**Town of Kittery  
 Planning Board Meeting  
 January 12, 2023**

**ITEM 3 – 41 Route 236 – Preliminary Site Plan Review**

**RE: Preliminary Site Plan Review – Request for Continuance  
Well Field 44 Cannabis Dispensary (Tax Map 29, Lot 1)  
41 Route 236, Kittery, Maine**

LANDSCAPING PLAN  
WELL FIELD 44 CANNABIS DISPENSARY  
41 ROUTE 236, KITTERY, ME 03904

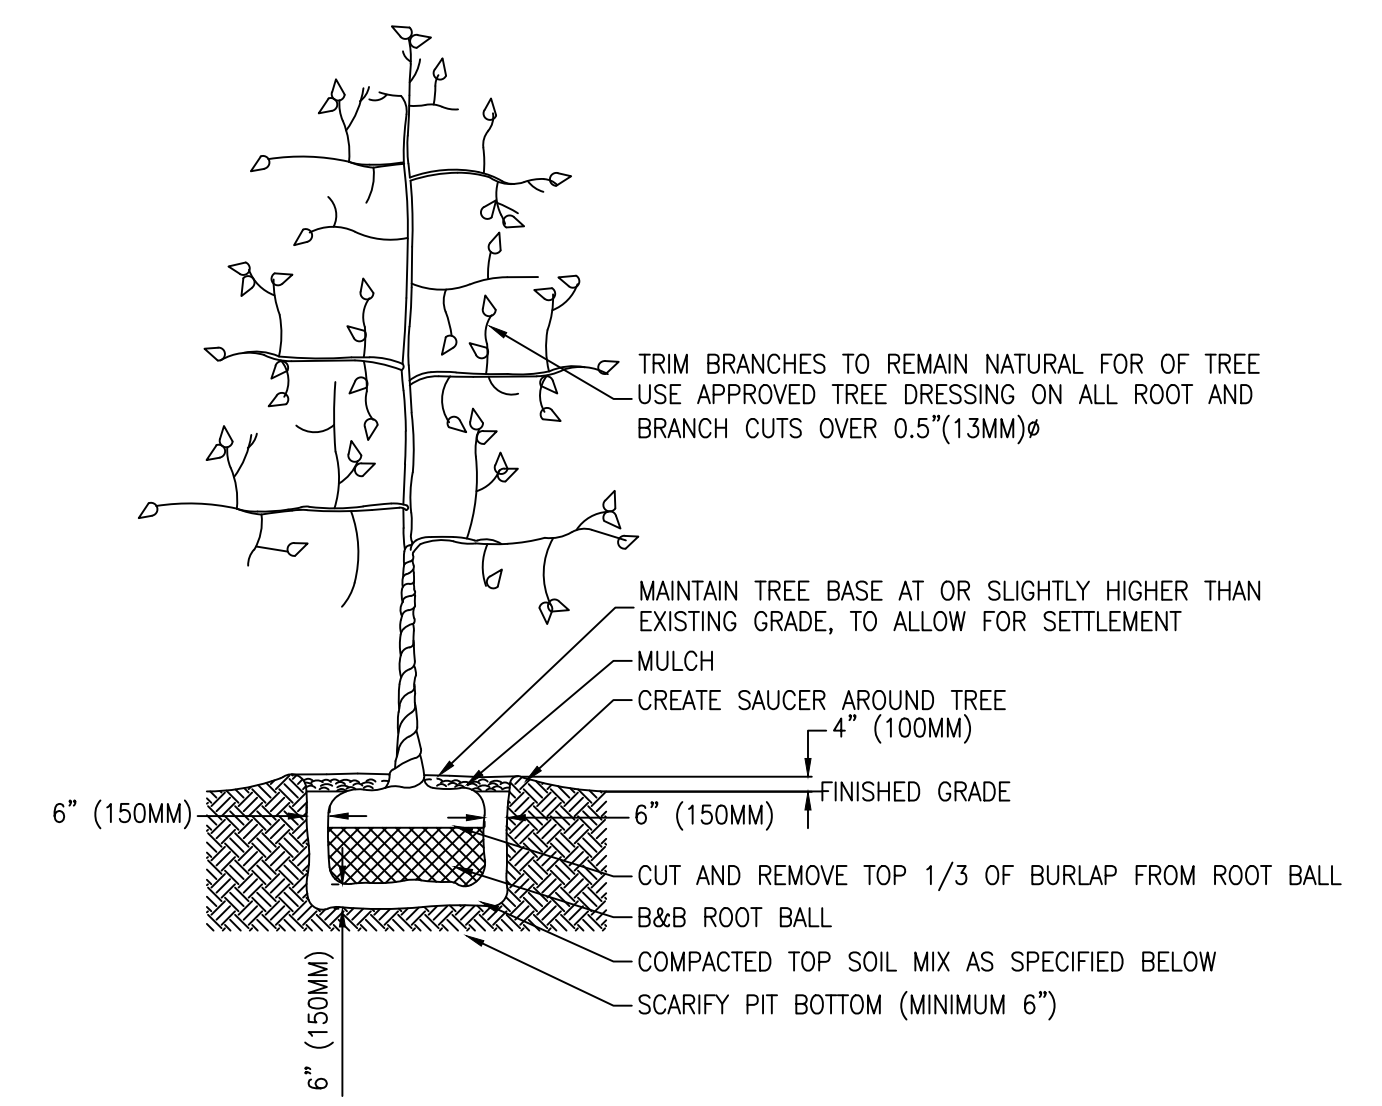
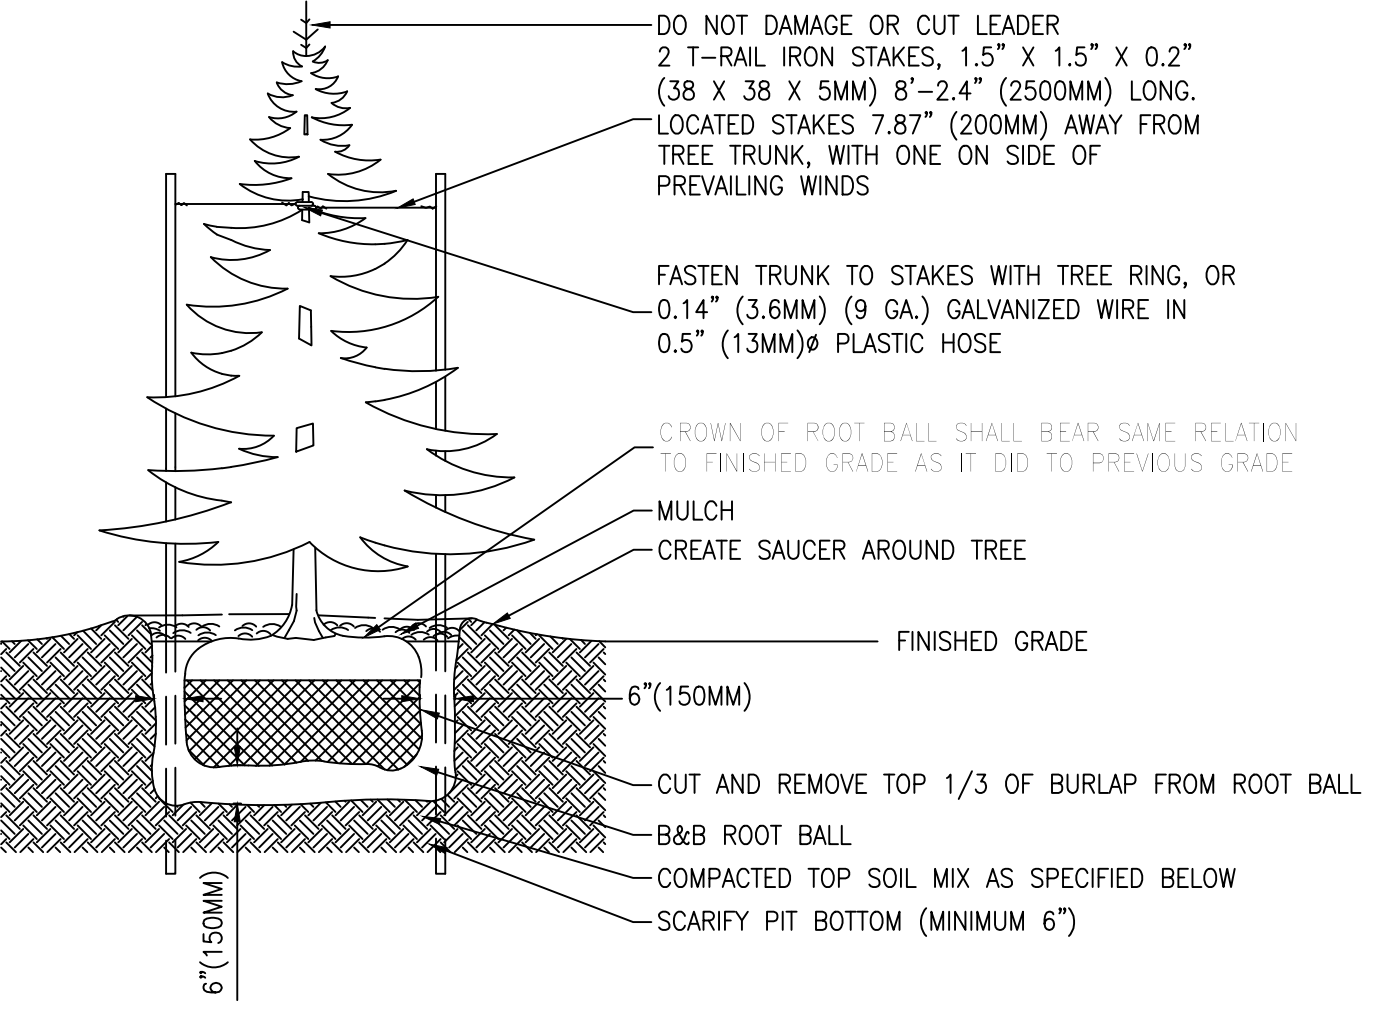
- The Landscaping Plan (Sheet 10) has been updated to include the required planting locations and details. Further information is provided below in the section of this Cover Letter pertaining to that Plan Set sheet.

- The Landscaping Plan (Sheet 10) has been updated to include typical planting details for all proposed plantings within the development. Additionally, notes are provided with each detail discussing installation and maintenance procedures.

- Vegetative screening planting locations, in the form of arborvitae along the northern edge of development, have been updated as discussed in an earlier section of the “Plan Set Comments” section.
